REMARKS

Reconsideration of the above-identified patent application, as amended, is respectfully requested.

FIG. 4

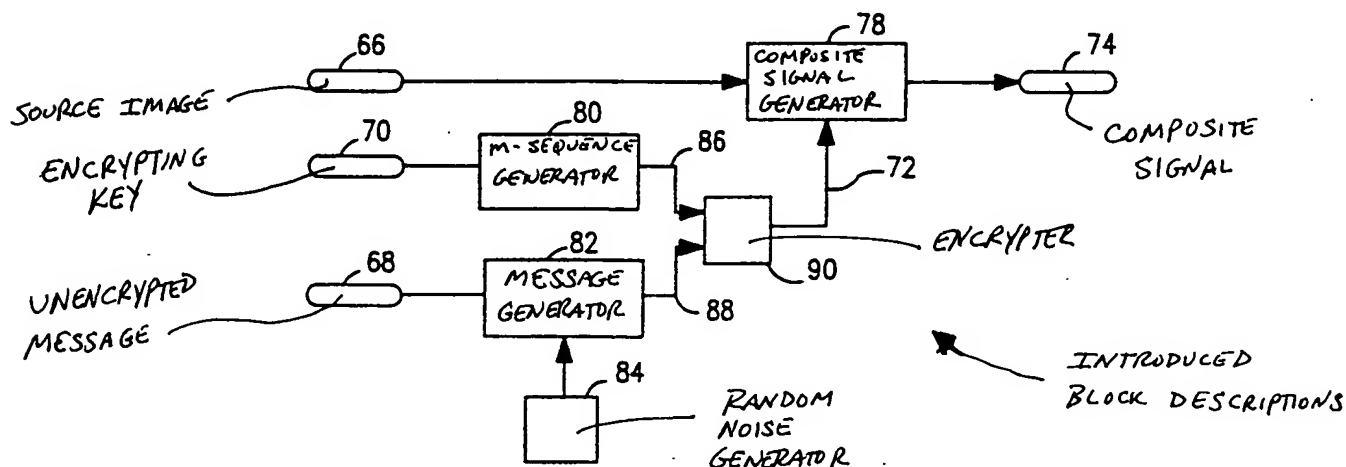
The drawings are objected to as requiring suitable descriptive legends for FIGS. 3 and 4. Applicants accordingly submit herewith a replacement sheet for FIGS. 3 and 4 and an annotated sheet showing changes FIGS. 3 and 4 that introduce functional block and signal descriptions were appropriate. These additions are fully supported in the specification and no new matter has been added.

The attached sheets of drawings include changes to FIGS. 3 and 4. The sheet identified in the top margin as a Replacement Sheet replaces the original sheet containing FIGS. 3 and 4. The sheet identified in the top margin as an Annotated Sheet Showing Changes is a marked-up copy of the original sheet containing FIGS. 3 and 4 showing the changes to FIGS. 3 and 4 in red.
